Hallsville School District

Progress Report #7

SITE OBSERVATION REPORT

Project: Hallsville School District – 2025 Bond Issue – Classroom Addition Project No: 24-5017

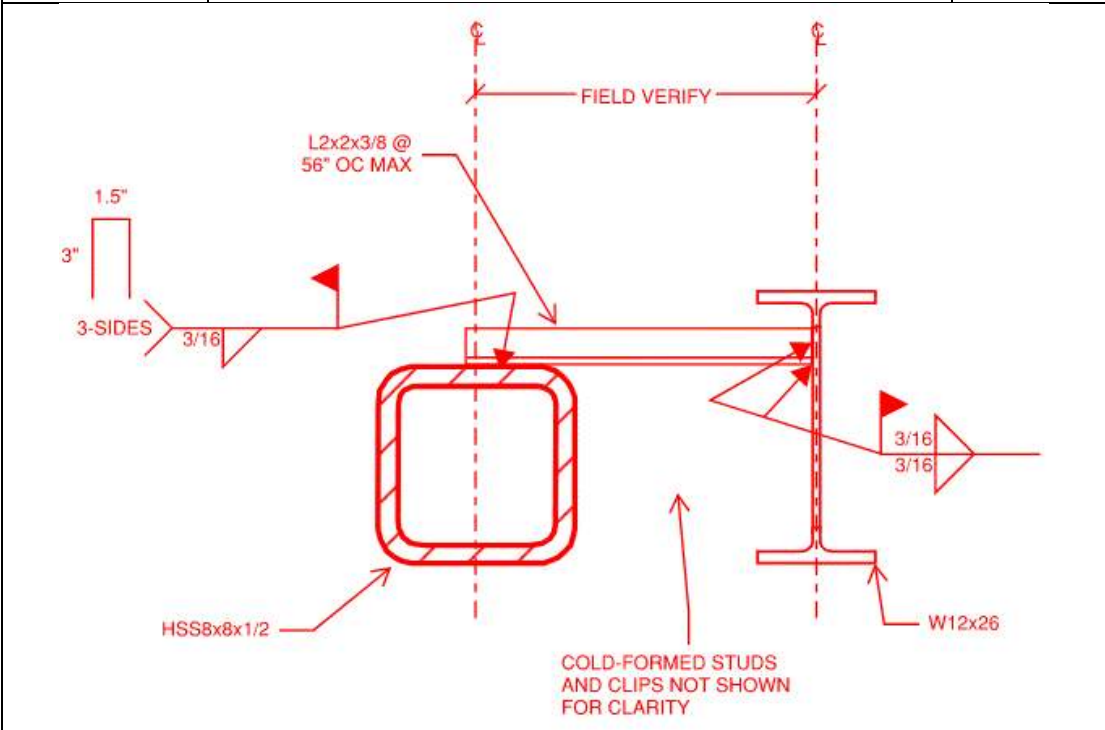
- The sidewall studs (north and south sides of the building) which were in-place had their Simpson SCHA Side-Clip connectors (approved alternate to Simpson SCB47.5 clips in 7/S510) attached between the studs and the WF beams running along Grids A & D (see attachment 1). Per detail 7/S510, the clips should have been attached to the HSS8x8 girts on the outside of the WF beams.

- Based on the heights of the sidewall studs, (2) rows of channel bridging are required per detail 4/S512. At the time of the visit, only (1) row of bridging had been installed (see attachment 3).

- Detail 3/S510 shows that the top track of the cold-formed stud wall, sitting directly on top of the (E) masonry wall, requires horizontal slots to allow for in-plane lateral moment. At the time of the visit, the top track did not have horizontal slots (see attachment 4).

- The structural and architectural drawings did not coordinate a roof edge angle to be provided on the east and west sides of the roof, to allow for trim attachment.

- In response to (E) condition A, a redlined detail (see attachment 2) was provided that laterally ties the WF beam to the HSS8x8 outside girt. This detail is to be used on both sidewalls where the Simpson SCHA Side-Clip connectors attach the studs to the WF beams.

- In response to (E) condition B, the (E) row of channel bridging will be removed and (2) rows will be installed (in the punchouts above and below the (E) row).

- In response to (E) condition C, the field confirmed that 2 ¼" long horizontal slots would be field-cut into the center of the top track web, to allow for 1" of lateral moment in either the north or south direction. In addition, fasteners with washers would be provided at these slots to allow for the aforementioned movement.

- In response to (E) condition D, 18GA angle (4"x6") was available on site and can be attached to the roof deck (long leg horizontal) to facilitate the attachment for roof edge trim pieces. The 18GA angle is to be attached to the roof deck (with a vapor barrier between) with #12 SDS at 12" on center.

- In lieu of a slotted pitch track as noted in detail 4/S513, an alternative detail using a build-up of light-gage pieces can be used instead (see attachment 5). This detail will be provided by EOD 9/3/2026.
